**RE: Construction Permit Application for a Proposed Utility Waste Landfill, Ameren Missouri
Labadie Energy Center, Franklin County, Missouri, Response to Comment Letter dated May 7,
2013**

Construction Permit Application
Proposed Utility Waste Landfill
Ameren Missouri Labadie Energy Center
Franklin County Missouri

Response to MDNR-SWMP Review Comments

**SHEET 3
PROPOSED UTILITY WASTE LANDFILL
PROJECT OVERVIEW**

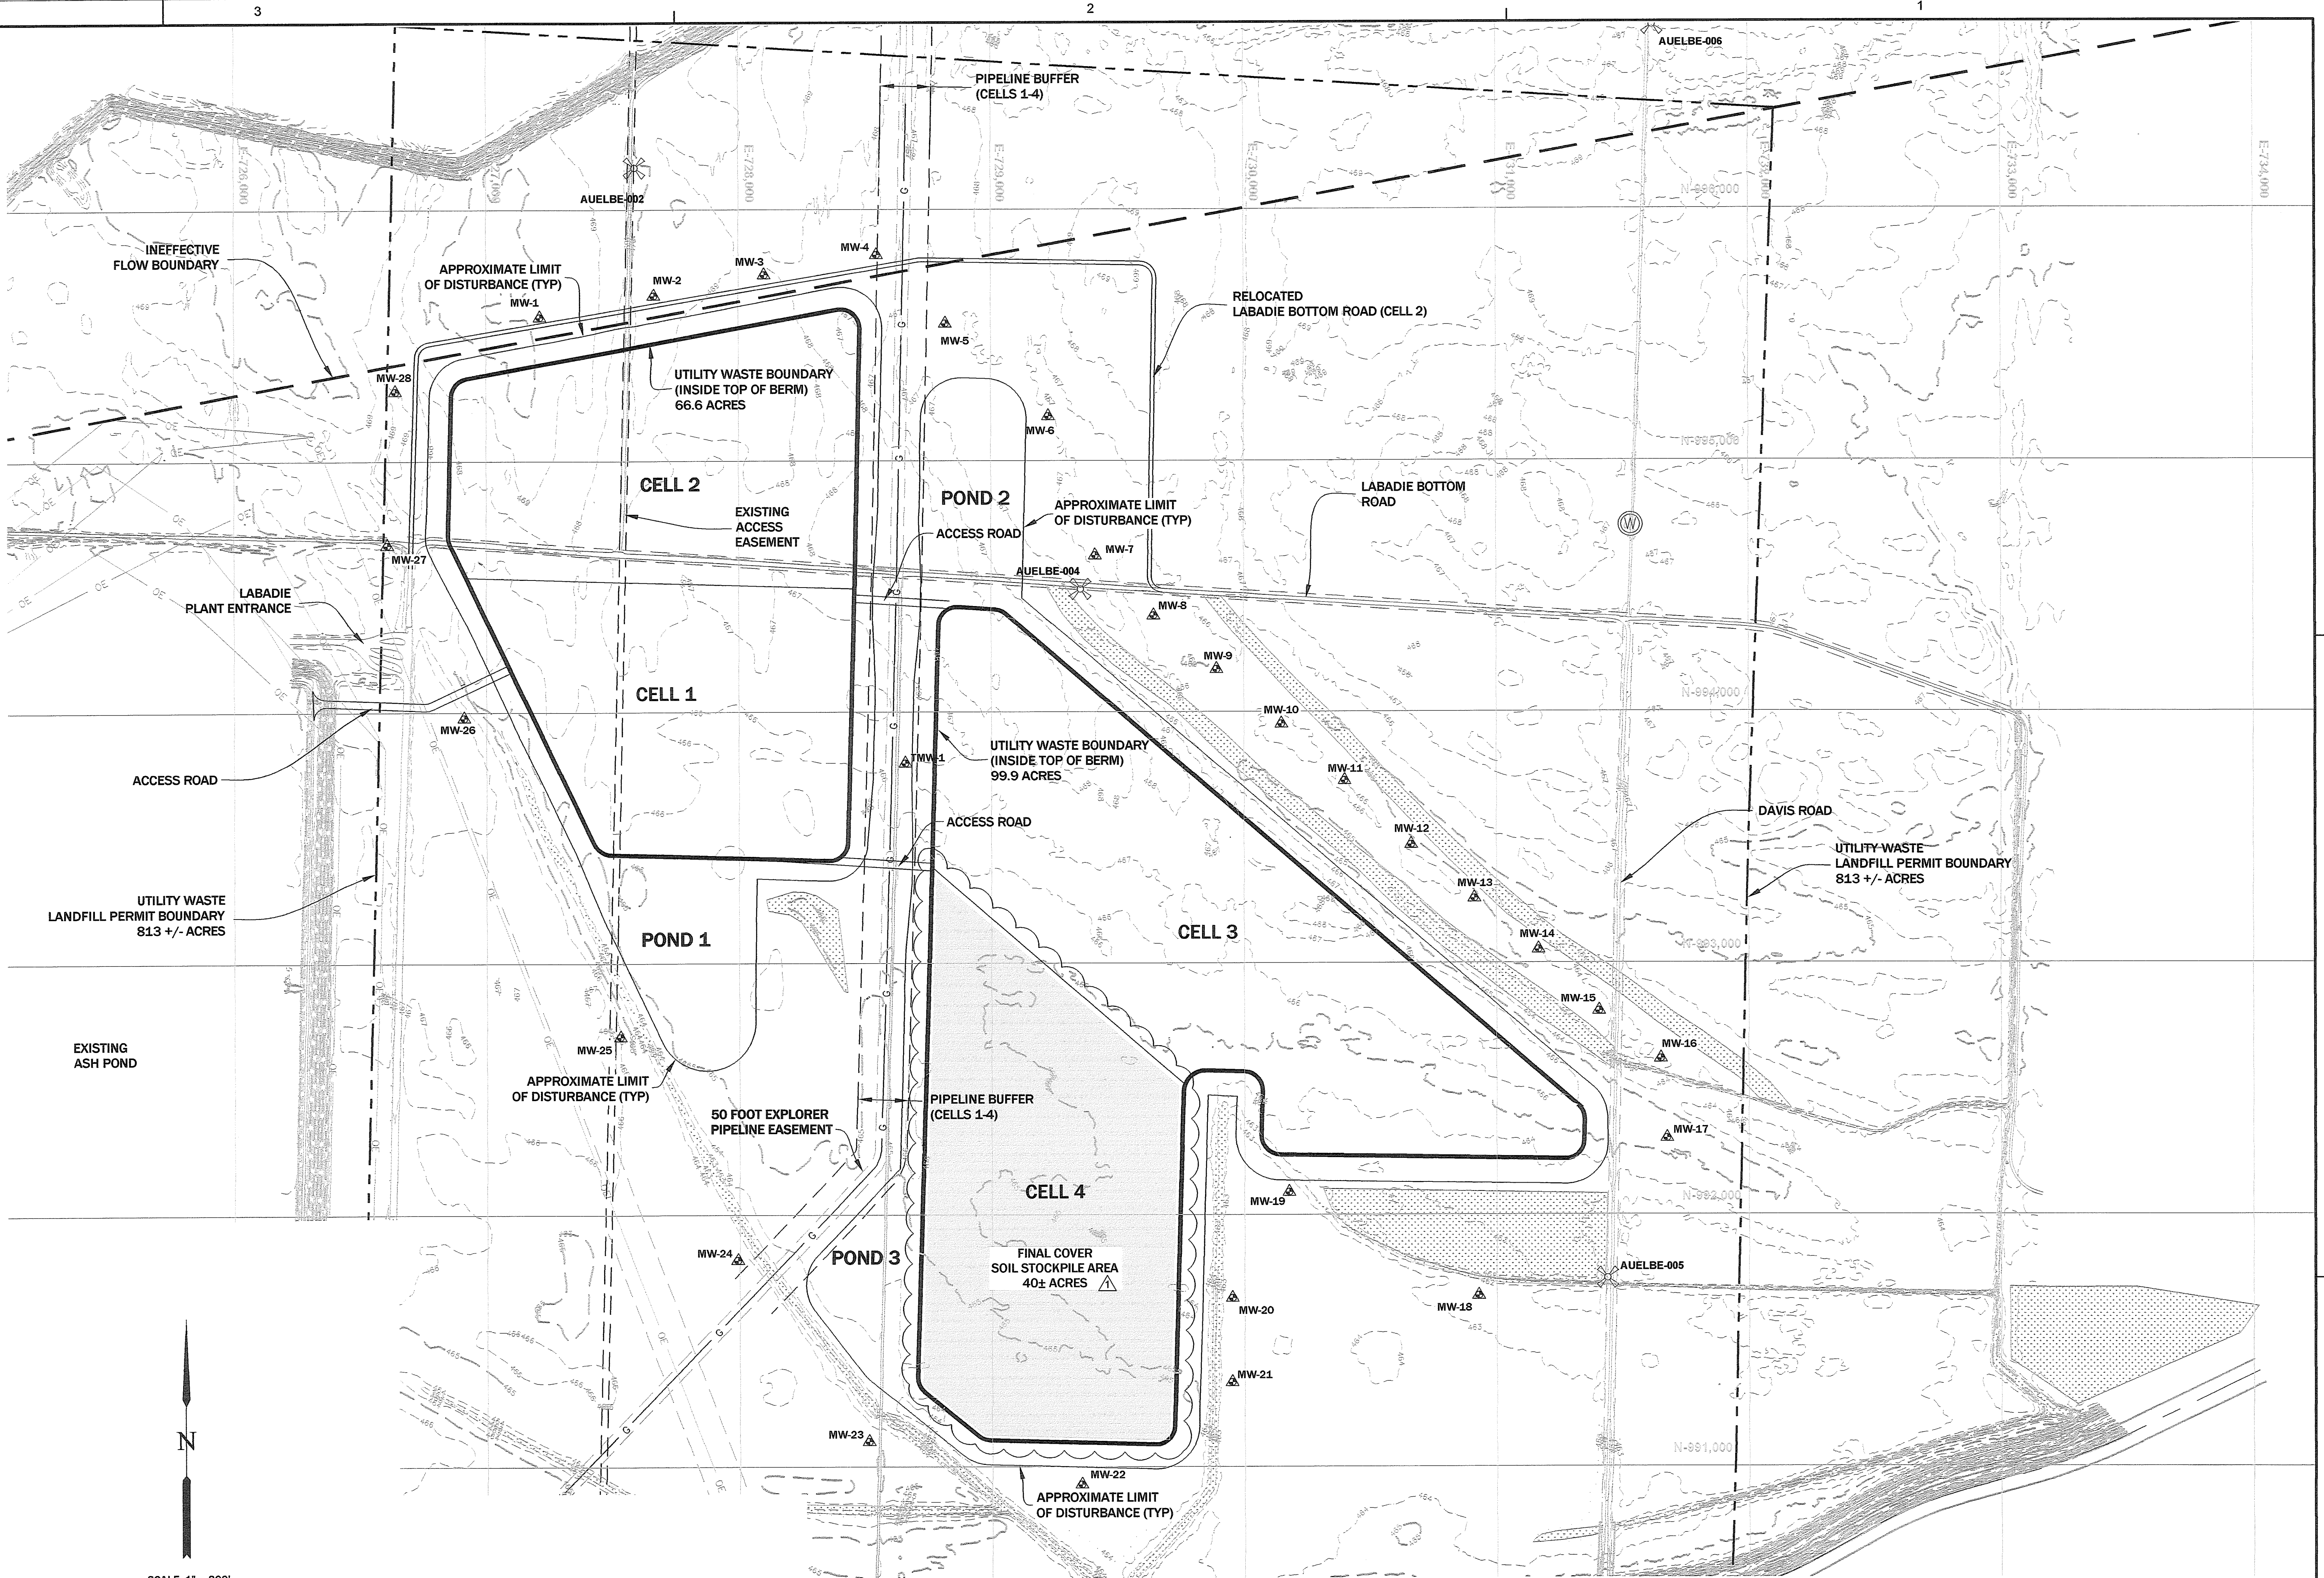
MDNR 6 Per 10 CSR 80-11.010(4)(B)2.A., please show the setbacks to wetland areas and other buffers on Sheet 3. **Response:** Sheets 3, 5, 10 and 19 have been revised to identify a minimum 25 foot buffer between the limits of disturbance and jurisdictional wetland areas. A note has also been added to Sheet 3 regarding the limited activities allowed north of the Ineffective Flow Boundary (i.e. no fill may be placed north of the Ineffective Flow Boundary).

MDNR 16 Per 10 CSR 80-11.010(4)(B)5.D., please indicate location and quantity of closure cover material dedicated to the Department, and depict this area on Sheet 3 of the plans. **Response:** Final cover needs are calculated in Appendix K to be 591,000 cubic yards of soil. Sheet 3 shows the outside toe of the exterior berms (the approximate limits of disturbance) to be 225 acres (Appendix K). During construction of the landfill, we previously indicated that 1.5 feet of soil suitable for final cover would be excavated from within the berm limits to establish

08/02/13: ADD BORROW AREA
ADD NOTES.

1. NO FILL MAY BE PLACED NORTH OF THE INEFFECTIVE FLOW BOUNDARY.
2. ALL LAND DISTURBANCE ACTIVITIES WILL HAVE A 25' MINIMUM SETBACK FROM JURISDICTIONAL WETLANDS WITH A STORMWATER BMP INSTALLED BETWEEN THE DISTURBANCE AND THE WETLAND DURING CONSTRUCTION. SEE DETAIL 4 ON SHEET 19.

1. WETLAND = MIN. 25'
2. INEFFECTIVE FLOW AREA = MIN. 0'
3. PIPELINE SETBACK = VARIES

SHEET 4
PROPOSED UTILITY WASTE LANDFILL
LAND USE AND ZONING WITHIN ONE
QUARTER MILE

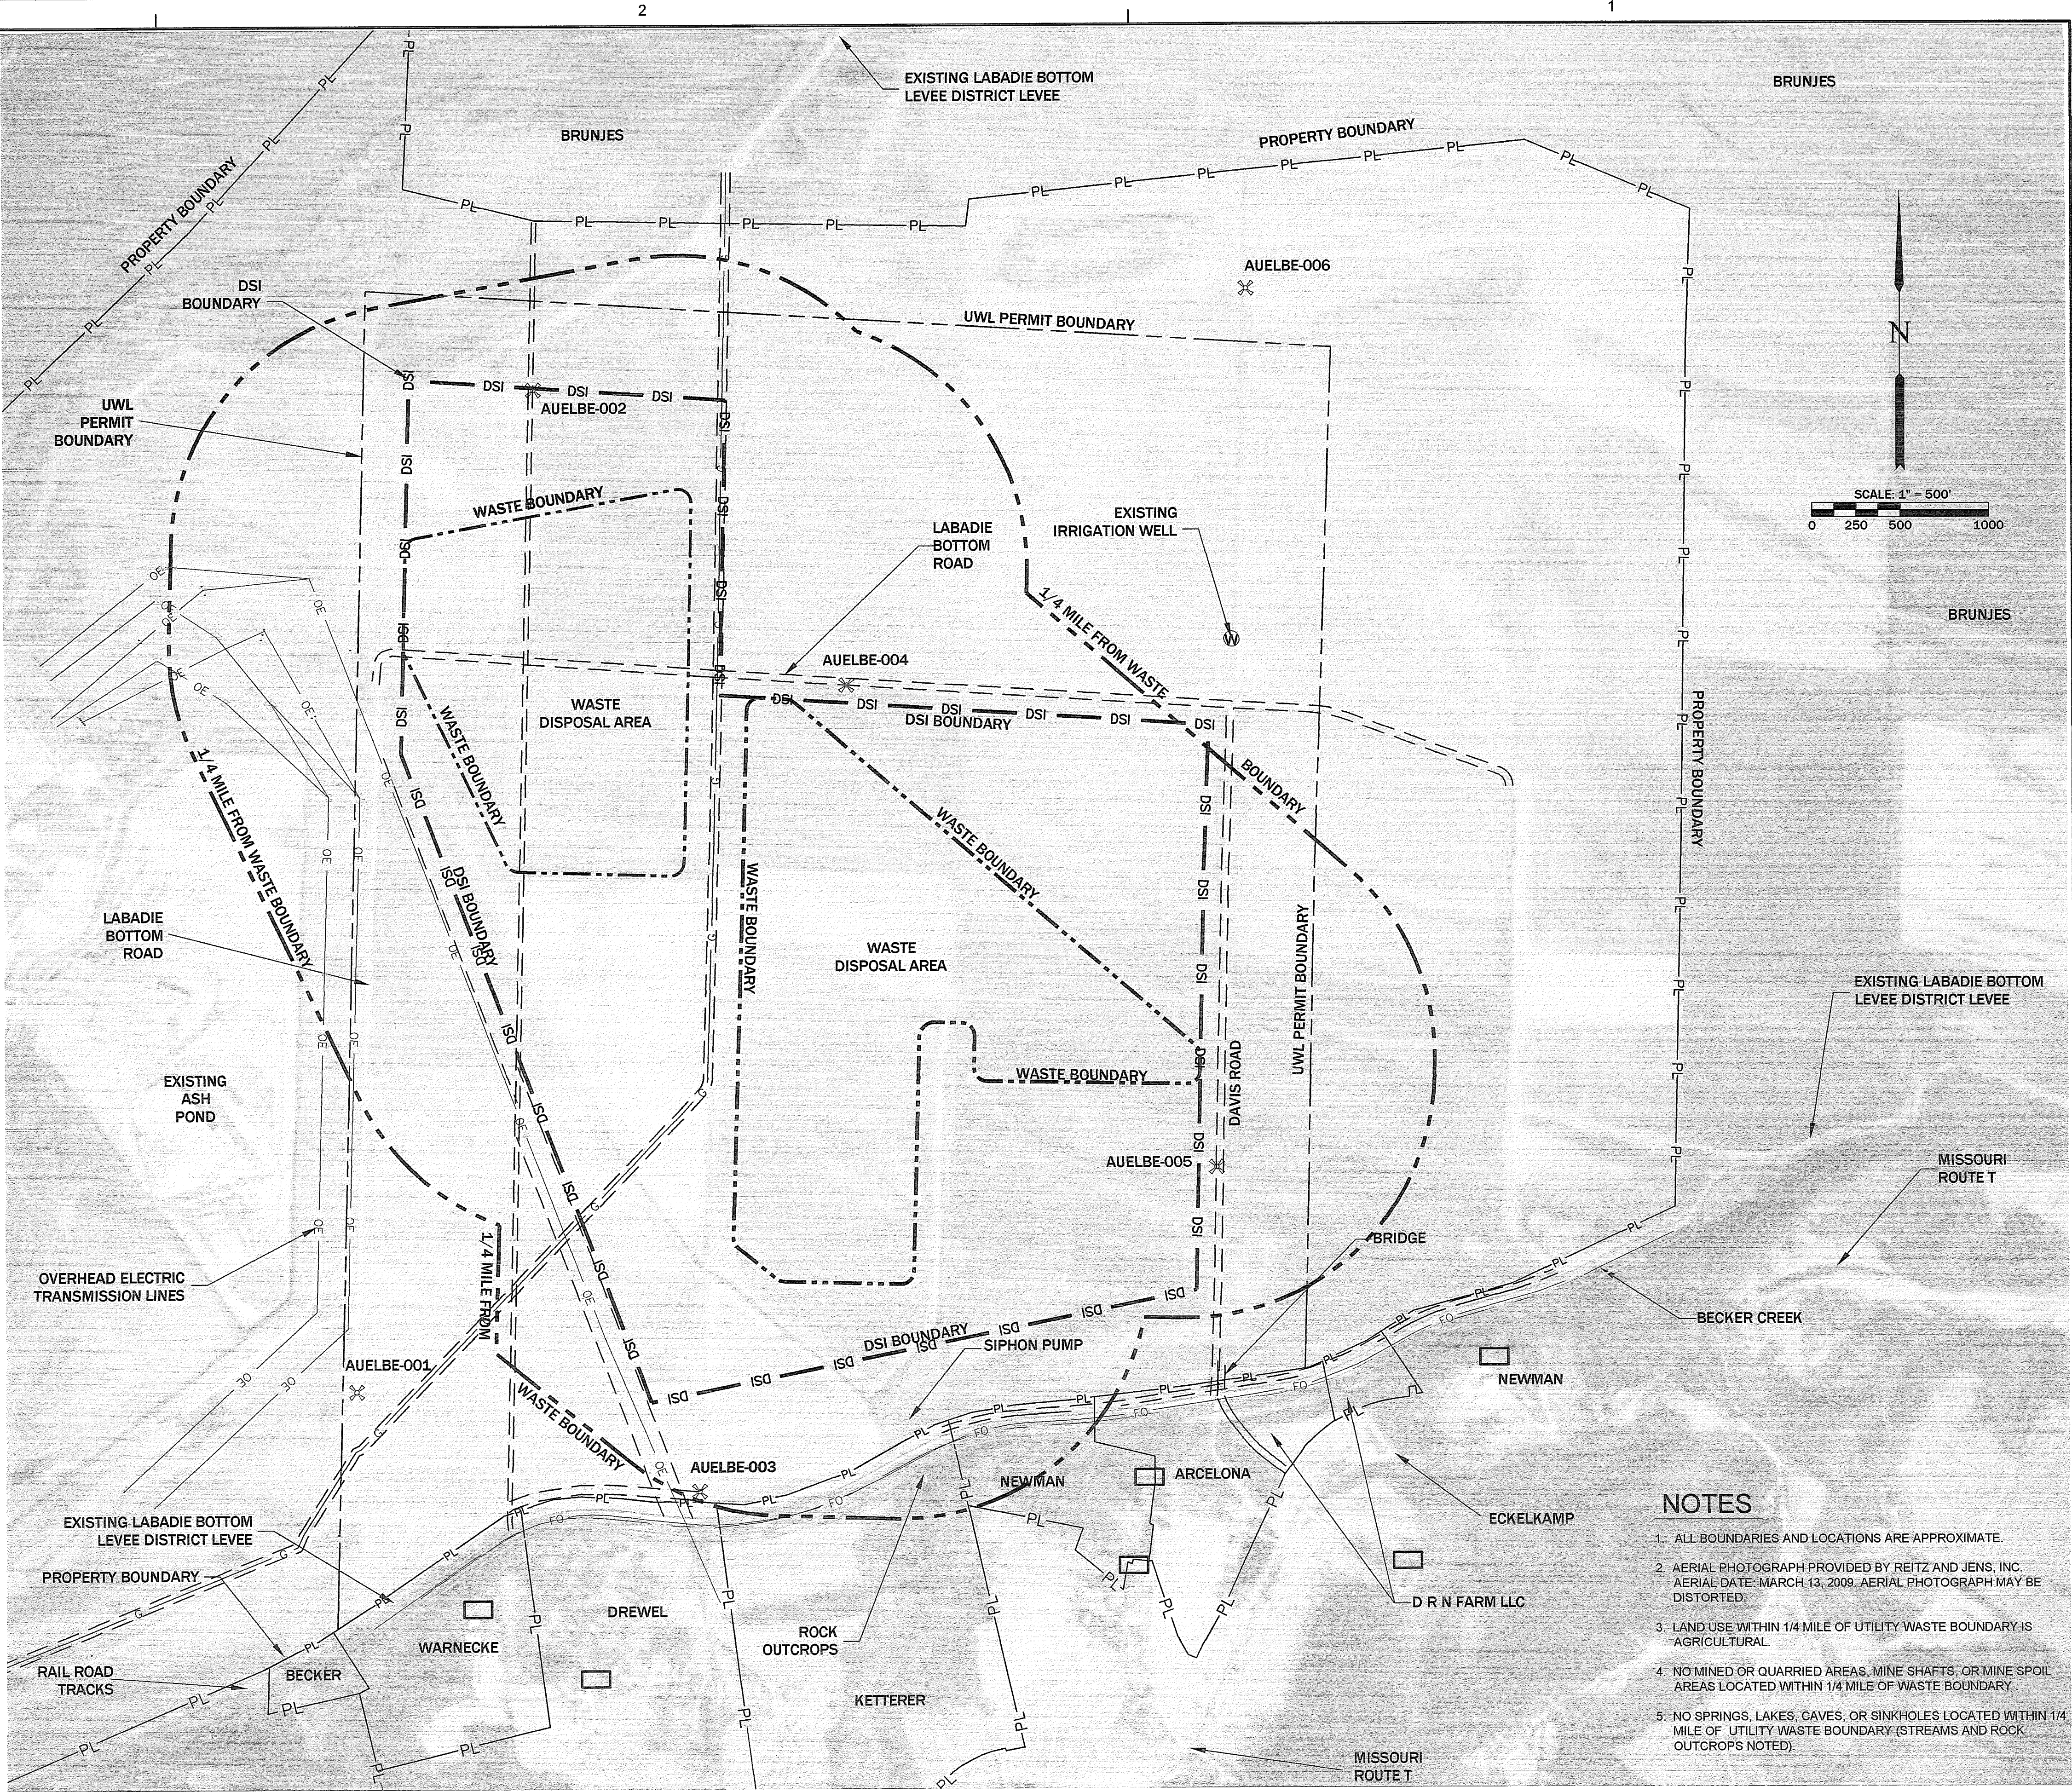
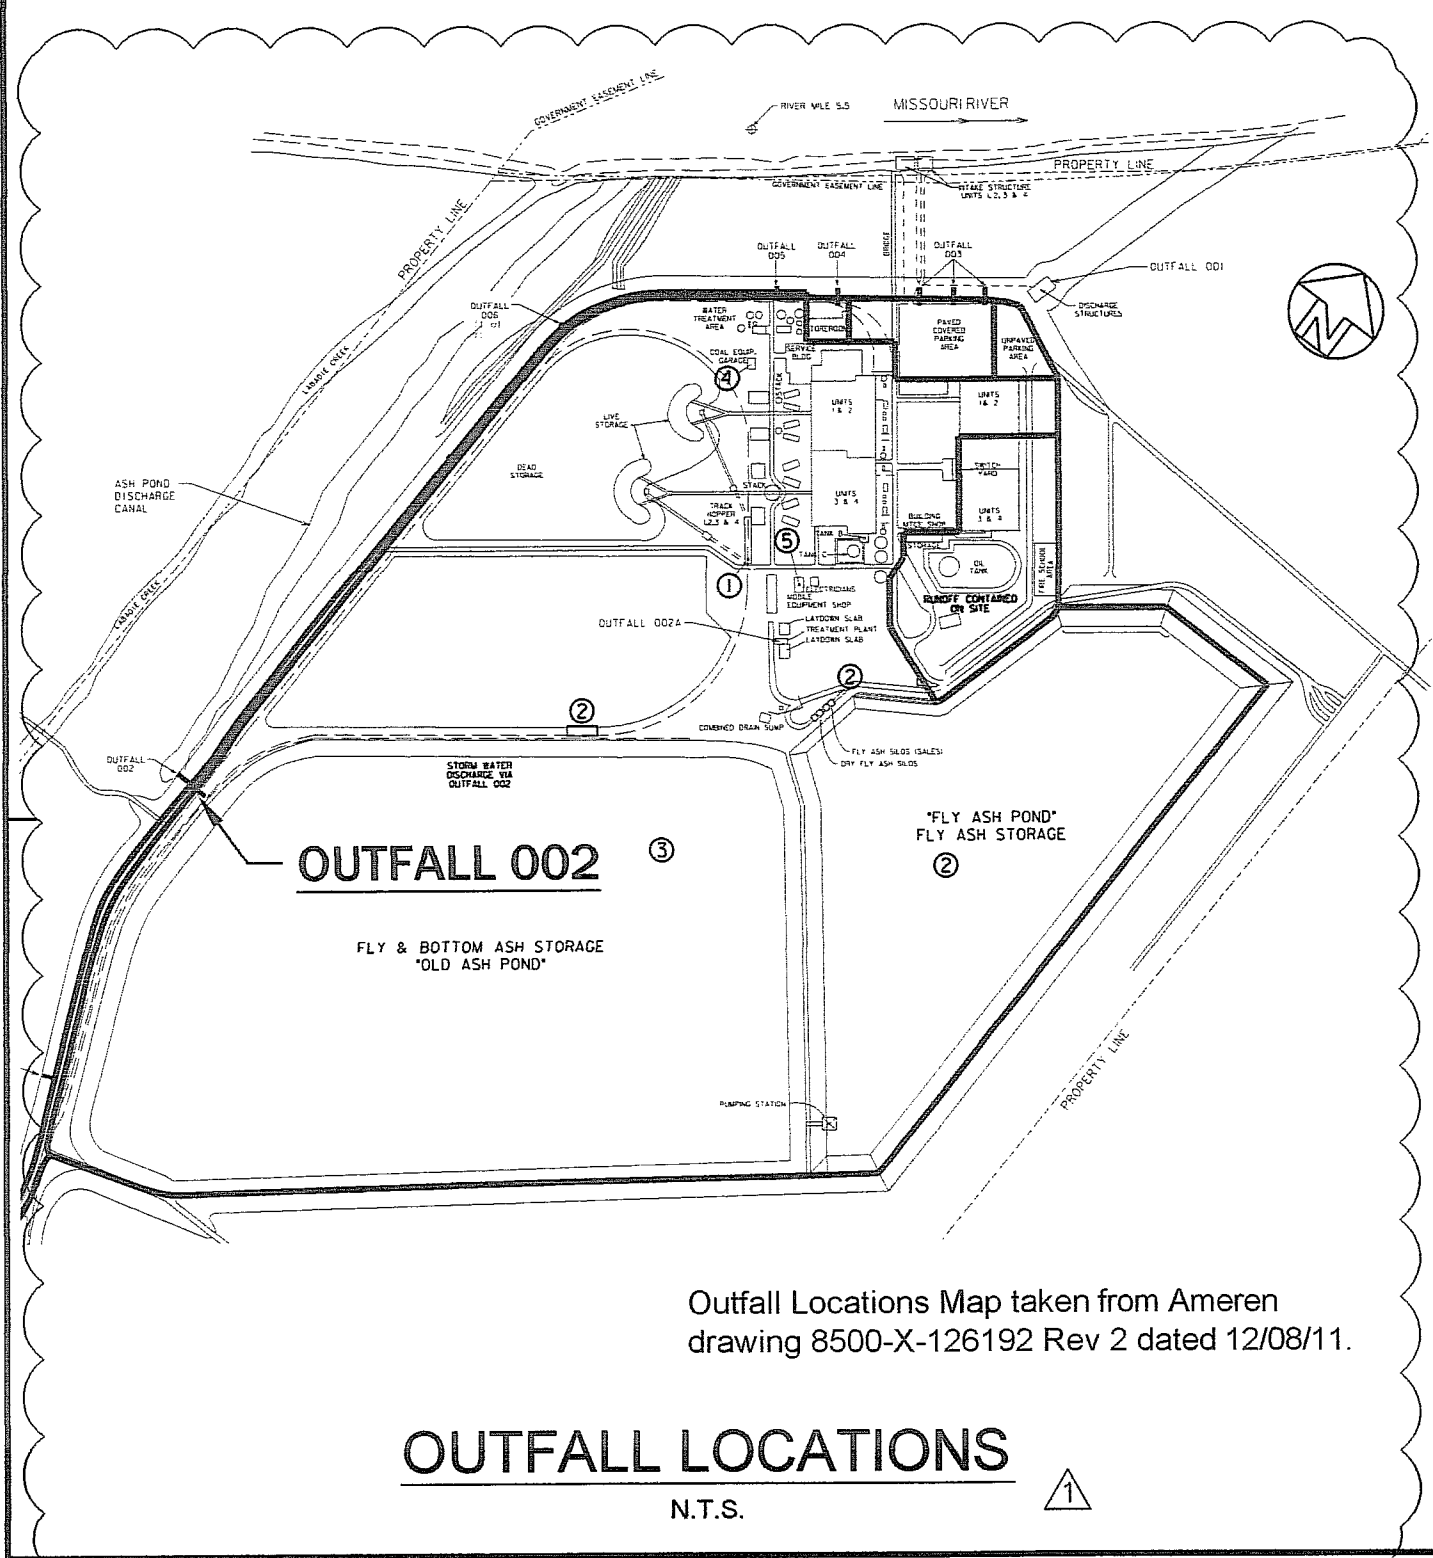
MDNR 7 Per 10 CSR 80-11.010(8)(B)1.F., please show the location of all National Pollution Discharge Elimination System (NPDES) outfalls where this new facility will drain to on Sheet 4. **Response:** Leachate and stormwater that cannot be utilized within the UWL limits for dust control or for conditioning of the ash prior to disposal in the UWL will be pumped back to ash ponds at the plant for discharge through NPDES Outfall 002. The plant map showing the location of Outfall 002 has been added to the lower left-hand corner of Sheet 4.

PRINT	DIST.
REV.	W.O.
1	1
06/02/12 ADD OUTFALL LOCATION INSET

OUTFALL LOCATIONS
